Contract No. T200411209.01
Federal Aid Project No. ESTP-S028(8)
SR 24, Mulberry Knoll to SR 1
Sussex County

Enclosed is Addendum No. 1 for the referenced contract consisting of the following:

Addendum No. 1
October 24, 2019

SECTION
AEC
SHEET NO.
6

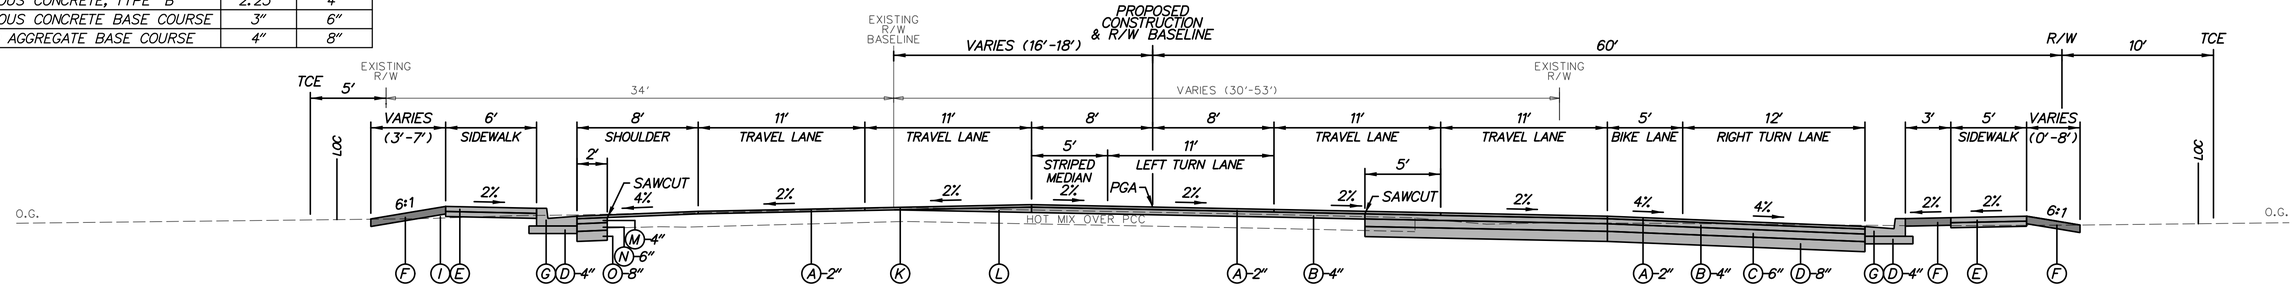
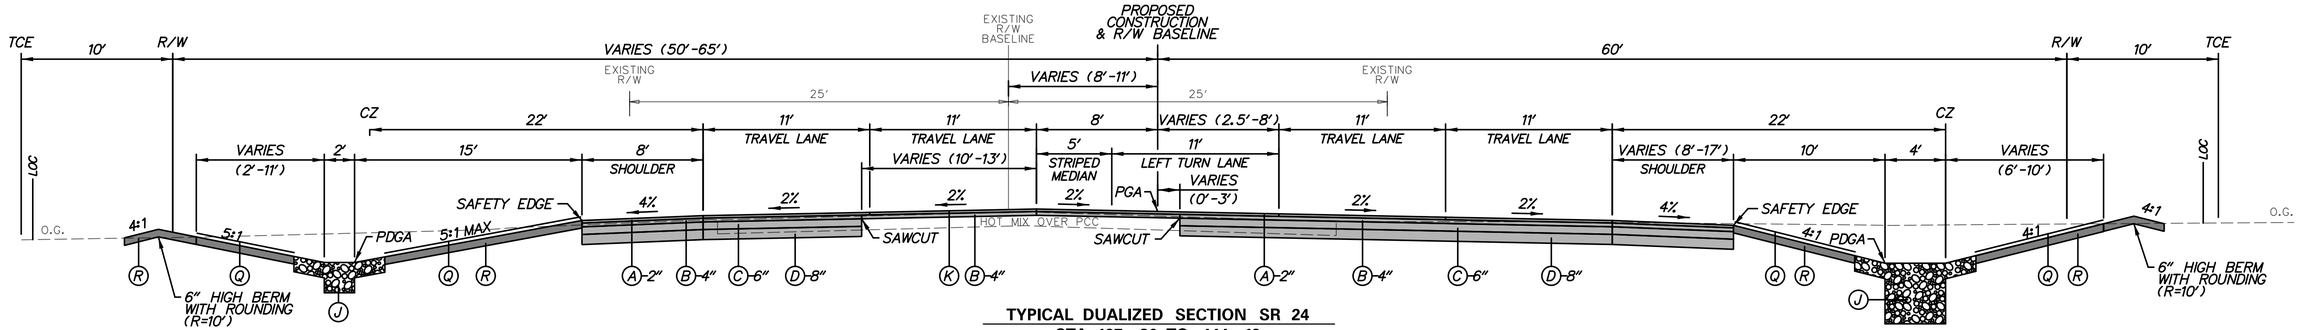
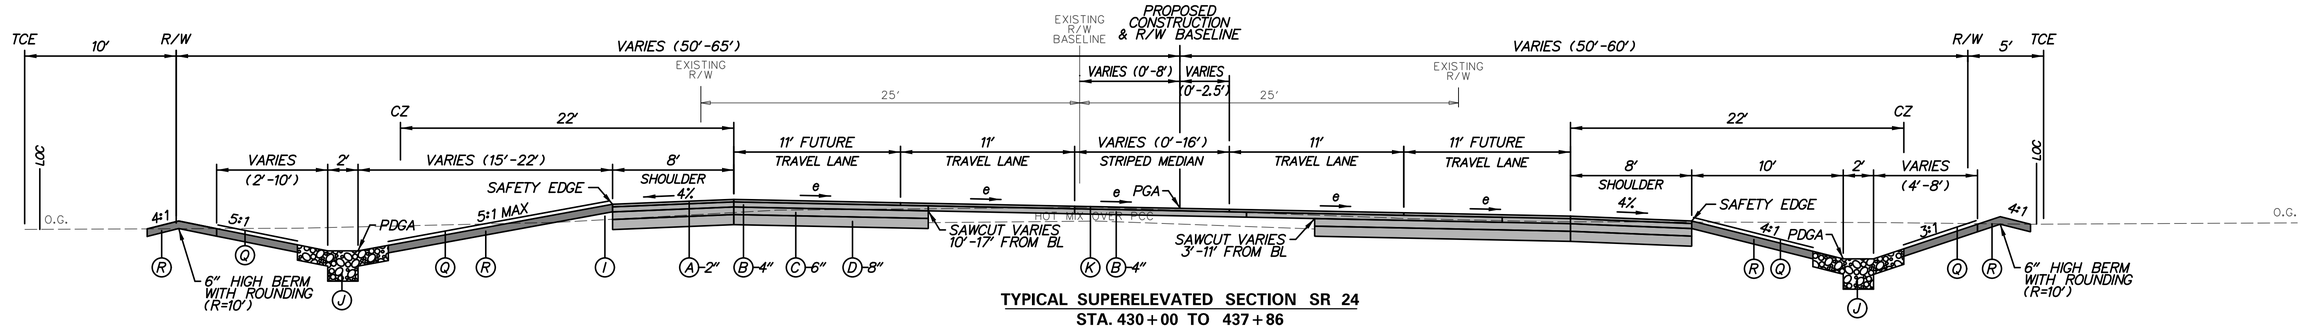
ADDENDA / REVISIONS		
△1 REVISED ITEM DESCRIPTION	D. SEMPLE 10/03/2019

CONTRACT	BRIDGE NO.	N/A	TYPICAL SECTION	SECTION
T200411209	DESIGNED BY: T. SINGLE			AEC
COUNTY				SHEET NO.
SUSSEX	CHECKED BY: D. SEMPLE			7

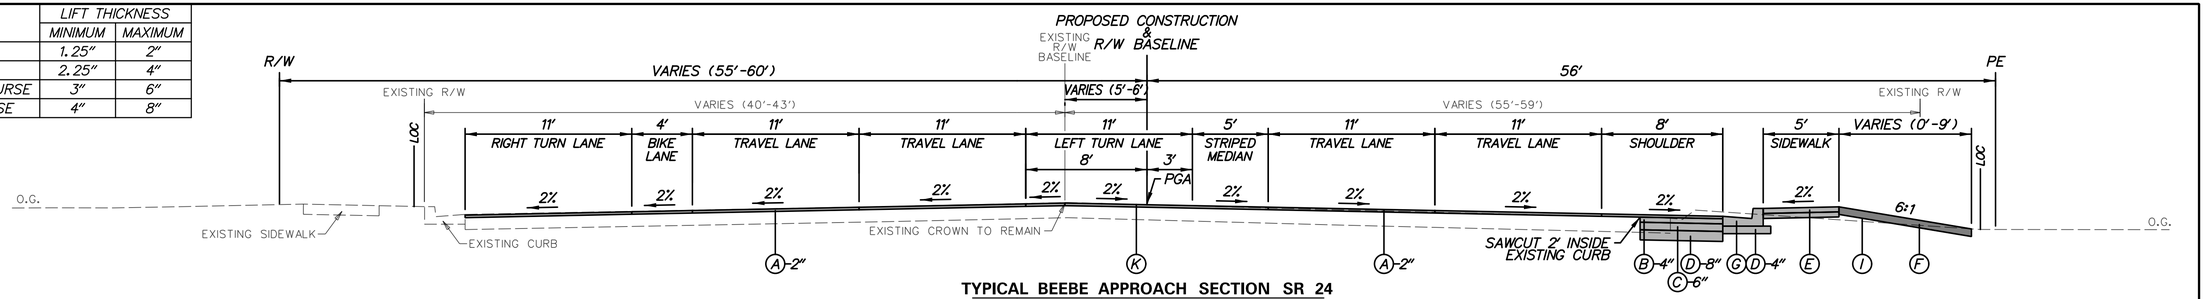
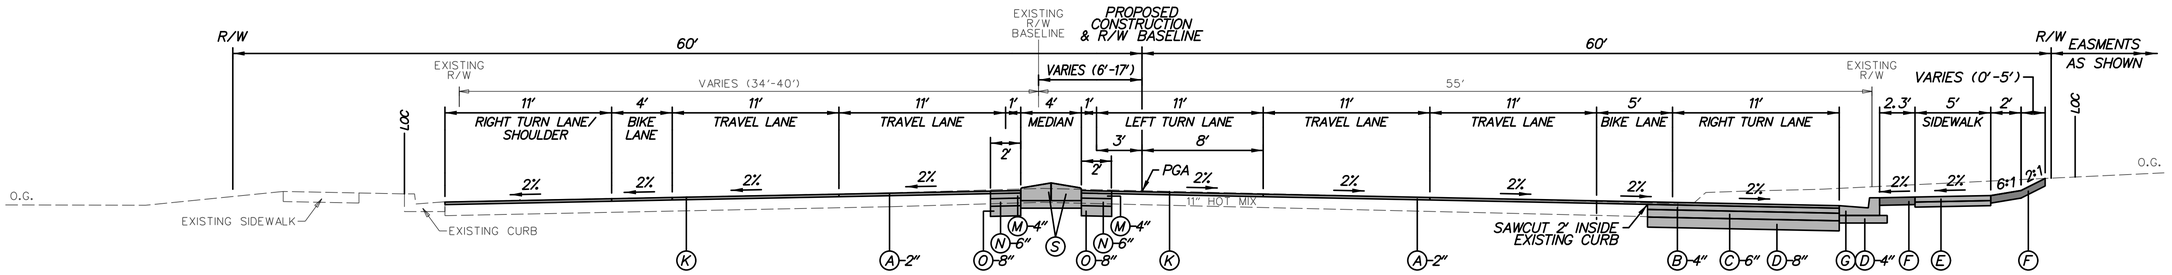
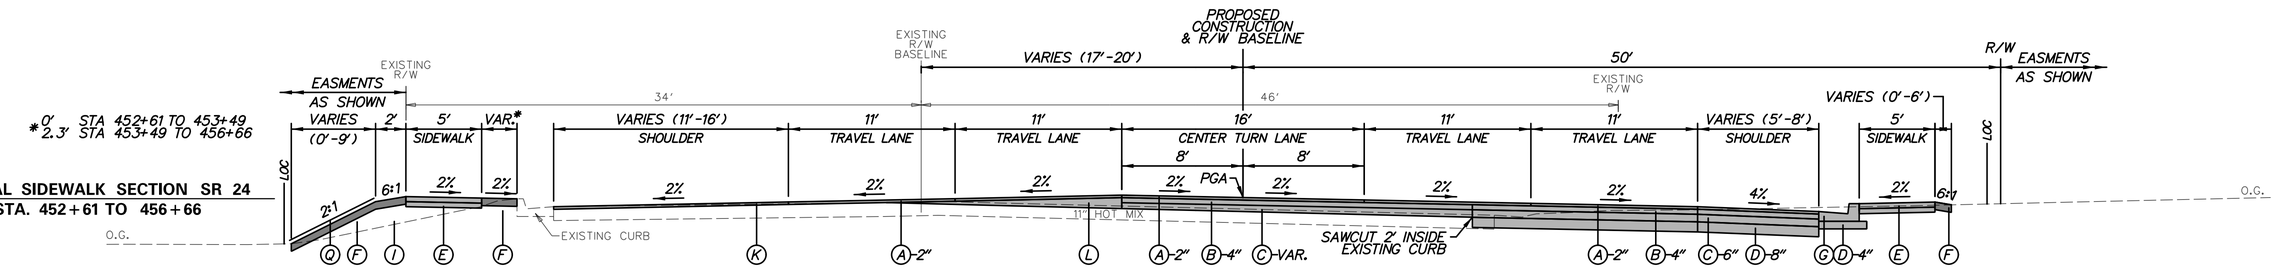
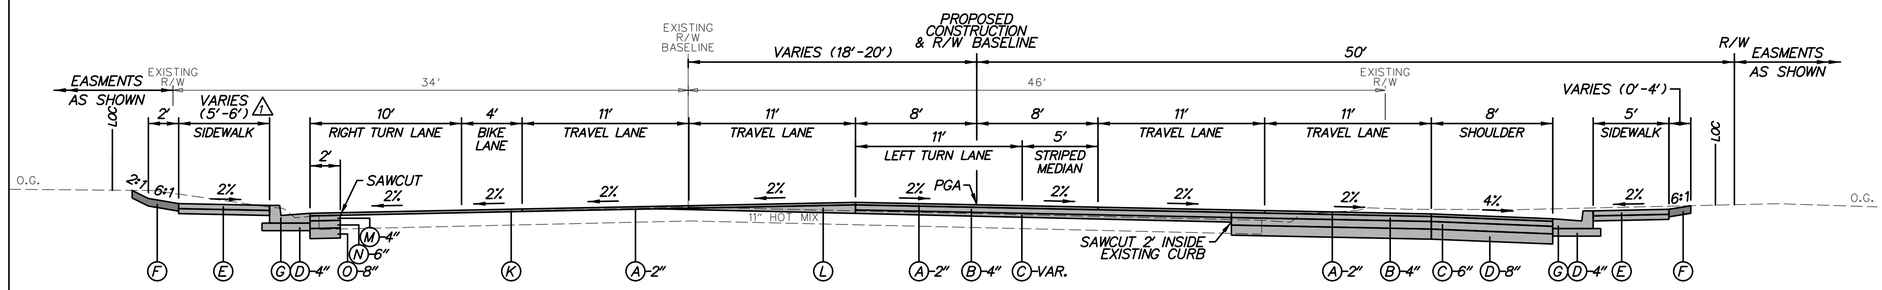
ADDENDA / REVISIONS	
(1) REVISED ITEM DESCRIPTION	D. SEMPLE 10/03/2019

SECTION
AEC
SHEET NO.
9

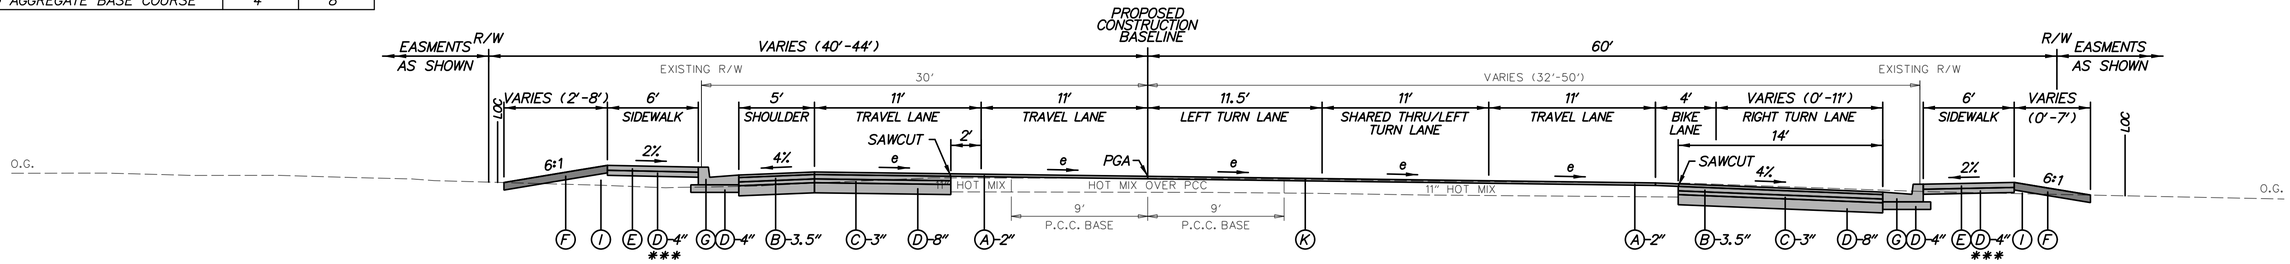
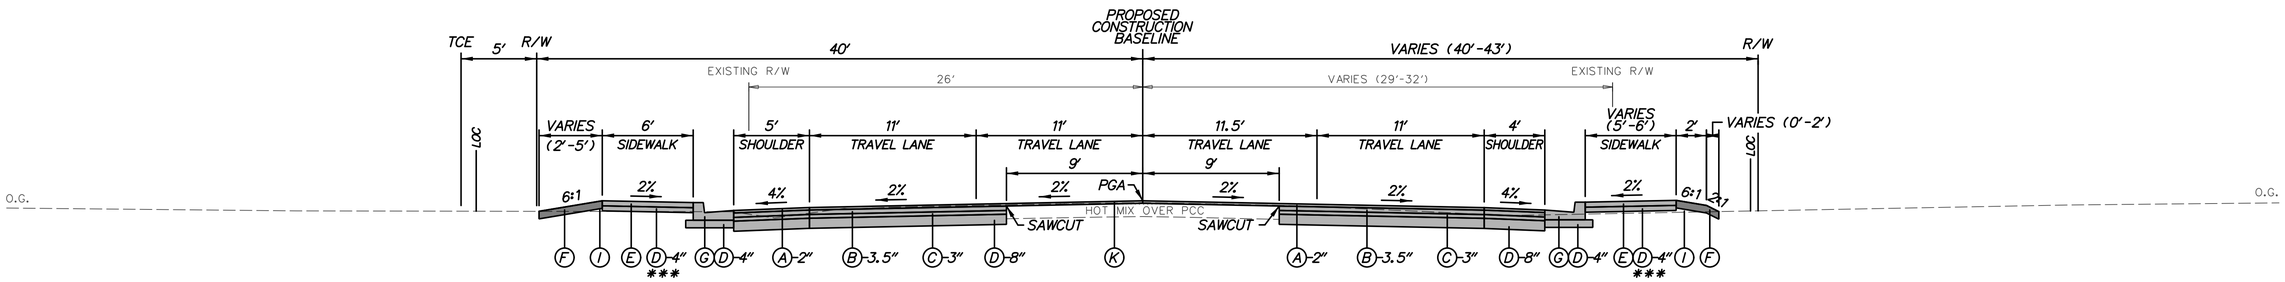
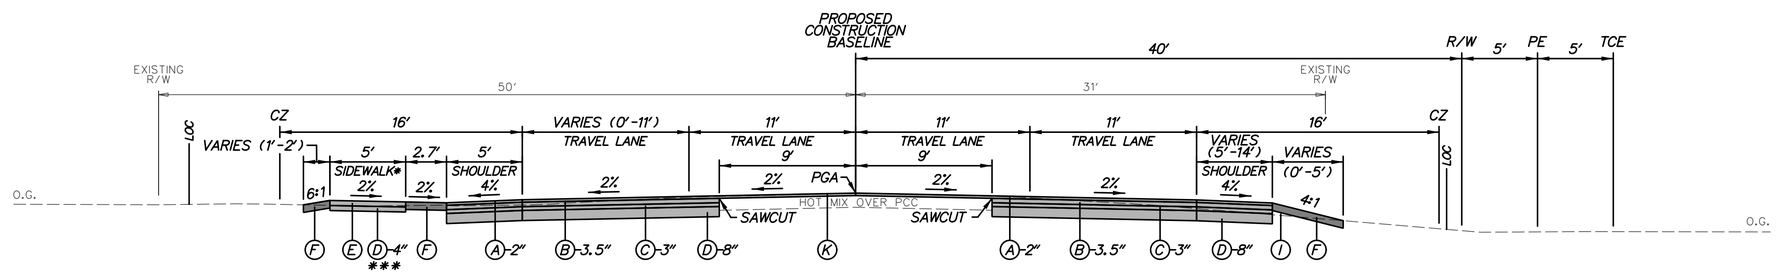
ADDENDA / REVISIONS		
1 REVISED ITEM DESCRIPTION	D. SEMPLE 10/03/2019

SECTION
AEC
SHEET NO.
10

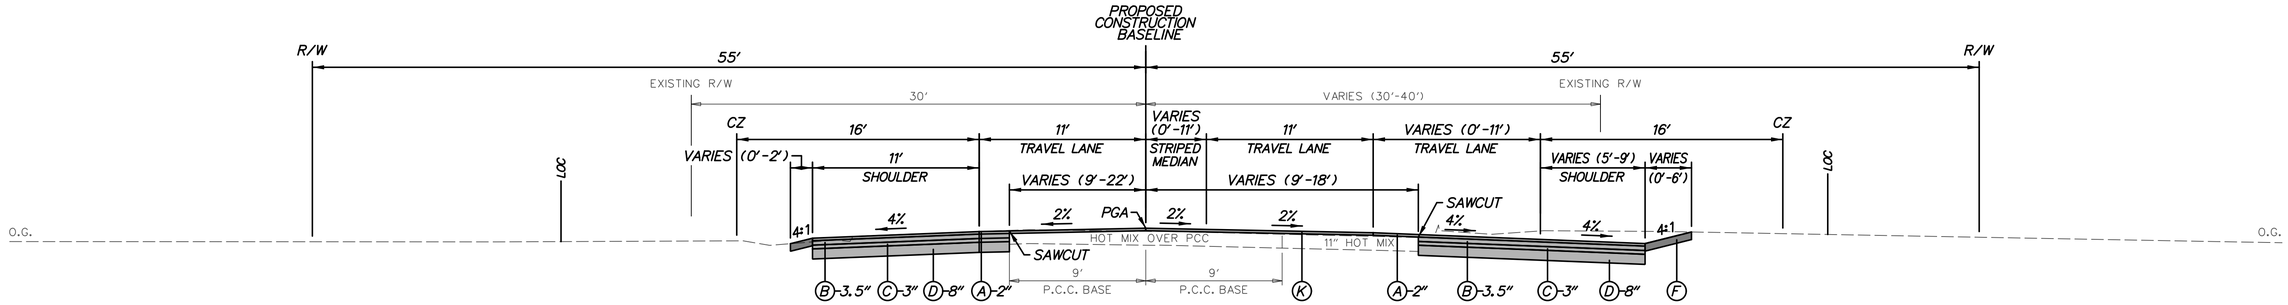
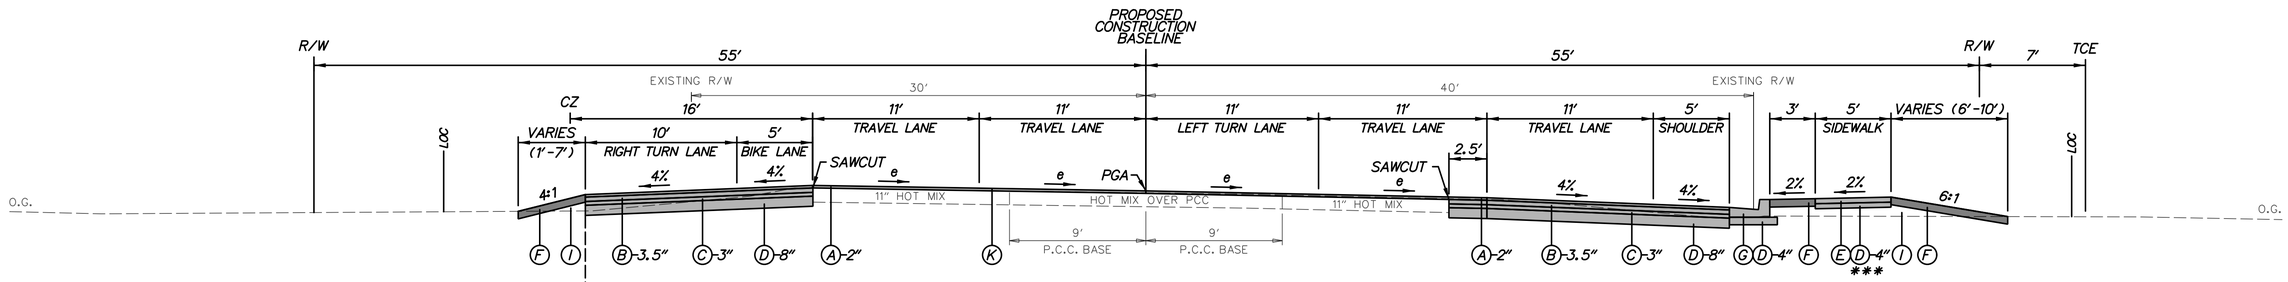
ADDENDA / REVISIONS		
(1) REVISED ITEM DESCRIPTION	D. SEMPLE 10/03/2019

CP-01
SECTION
AEC
SHEET NO.
13

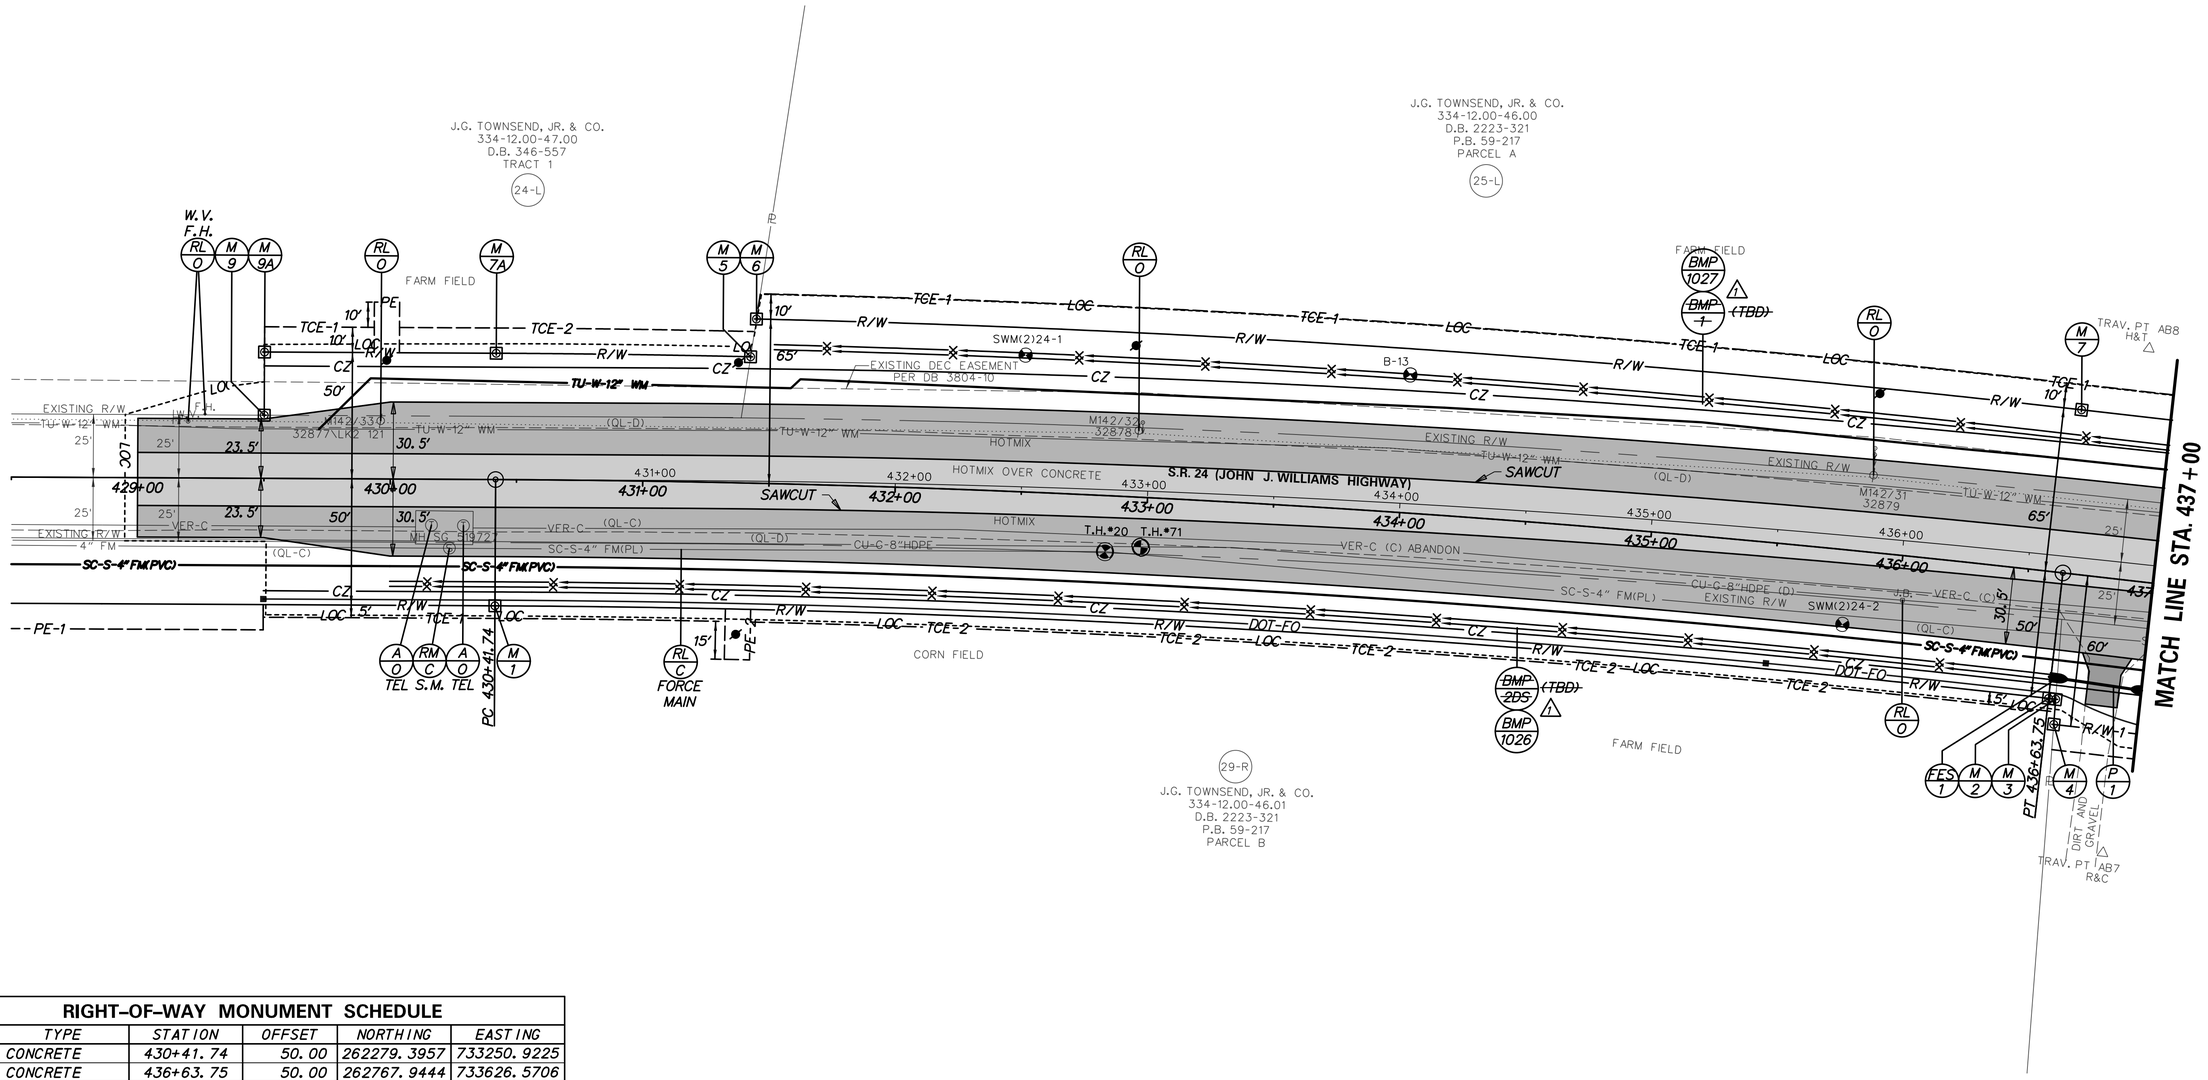
1 REVISED BMP NUMBERS AND DESCRIPTIONS — D. SEMPLE 10/03/2019

CP-02
SECTION
AEC
SHEET NO.
14

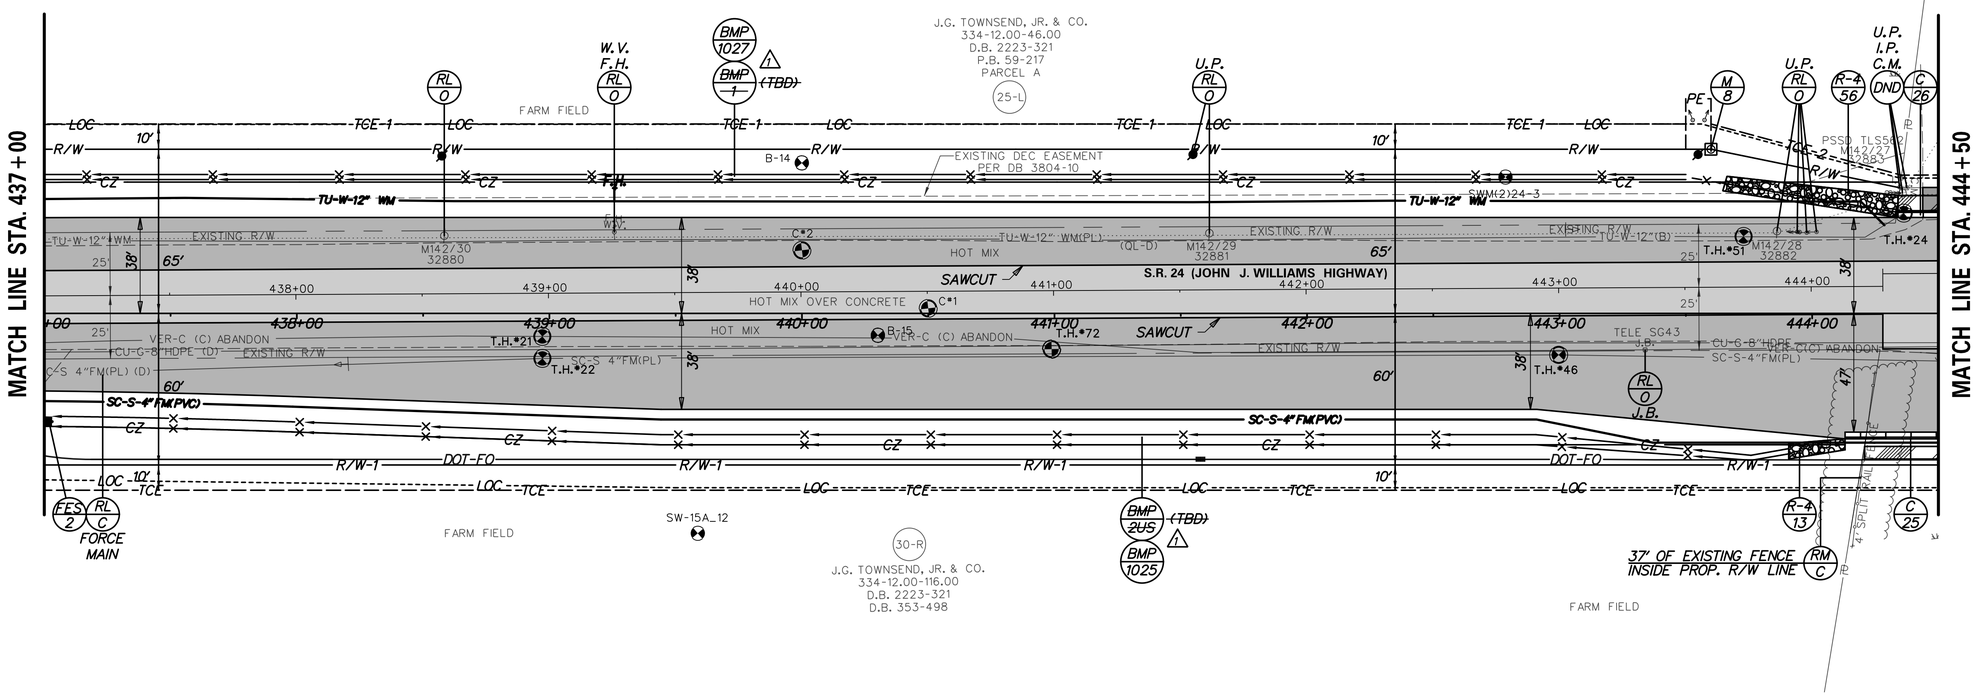
ADDENDA / REVISIONS		
1 REVISED BMP NUMBERS AND DESCRIPTIONS	D. SEMPLE 10/03/2019
